# 1. Reply to reviewer 1#

## Detailed revision:

## 2. Reply to reviewer 2#

Figure 1: Coordinate system of borehole trajectory.

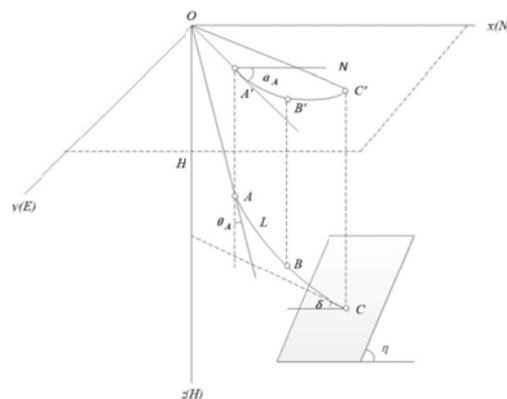
(1) The Figure 1 is not clear. It's better to be replaced by a clearer one.

(4) Figure captions are often extremely short, and consider clarifying the reference system and/or using different colours or width/type lines for each kind..

Modification: In the previous manuscript, Figure 1 is created by Microsoft Visio, so when it is directly converted to PDF, it is not clear. We will convert it into JPG format and it will be much clearer than before.

Explanation and modification: According to your suggestion, we have appropriately added figure captions for authors. We also added explanation information about the coordinate system, the curve and the angle of Figure 1 under it. In the previous manuscript, Figure 1 is created by Microsoft Visio, so when it is directly converted to PDF, it is not clear. We will convert it into JPG format and it will be much clearer than before.
